**TOWNSHIP OF LAWRENCE**  
**Engineering Department**

SUBJECT: Bulk and Use Variance Application No. ZB-3/19  
Major Site Plan – Preliminary & Final Approval Application No. SP-5/20  
Major Subdivision – Preliminary and Final Approval Application No. S-2/20  
**RPM Development**, 2495 Brunswick Pike  
Tax Map Page 20.01, Block 2001, Lots 2, 3, 5, 60 – 66 and 68

DATE: December 3, 2020

**Re:** RPM Development, LLC - Case No. ZB-3/19, SP-5/20, S-2/20  
Use Variance d(1) - Use, d(4) – Floor Area Ratio, d(6) - Height  
Preliminary & Final Site Plan  
Preliminary & Final Major Subdivision  
2495 Brunswick Pike  
Block 2001, Lots 3, 60 through 66, 68  
Highway Commercial (HC) & R-4 Residential District

Picture #2

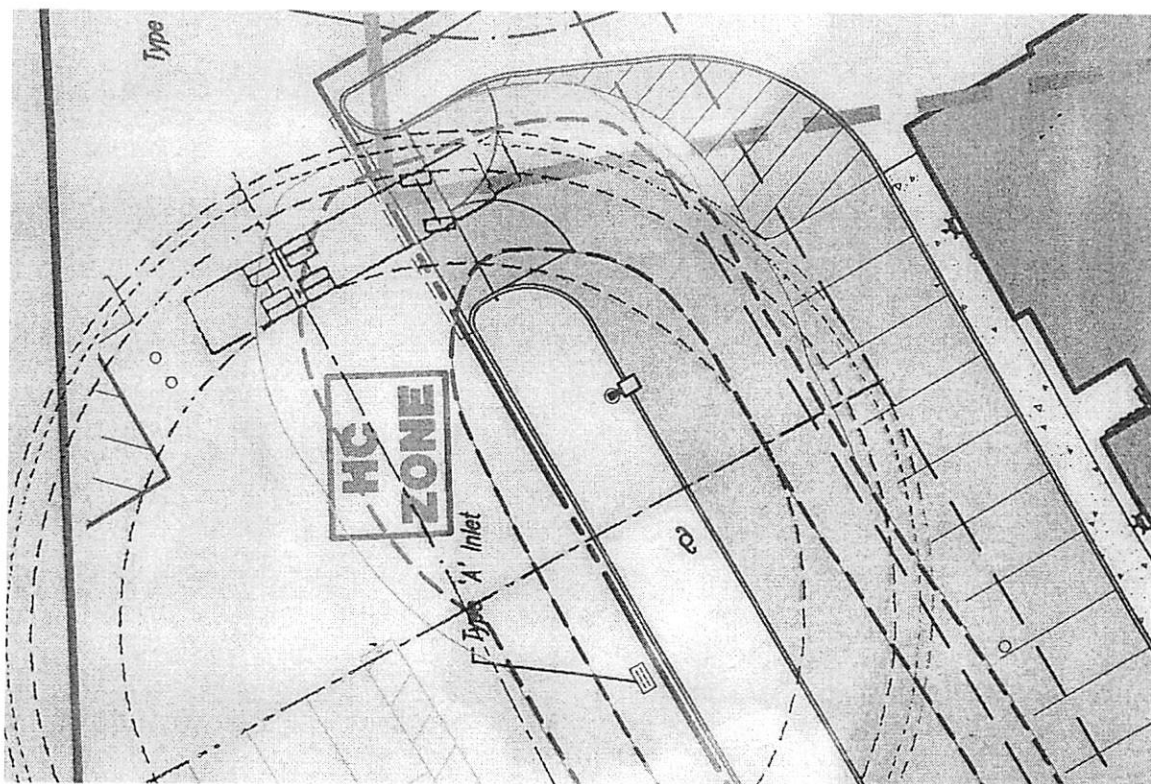
After review of the site proposal for fire truck access, The Lawrenceville Tower Ladder will still will have access restrictions. I have noted using my radius templet of Lawrenceville Tower Ladder, access into complex to parking area (picture #1) the Tower ladder does not clear the median or first parking space, the rear entrance from Lawrence Shopping center (picture #2) the Tower Ladder does not clear parking spots, next location is the rear left turn from rear entrance (picture #3) the Tower Ladder will not make the turn.

Designated Fire Lane Marking on curb line as well as signage will be required within complex as per Lawrence Township Ordinance #2060-10. Yellow striping along length of curb as indicated in site map provided and "NO PARKING FIRE LANE" signs.
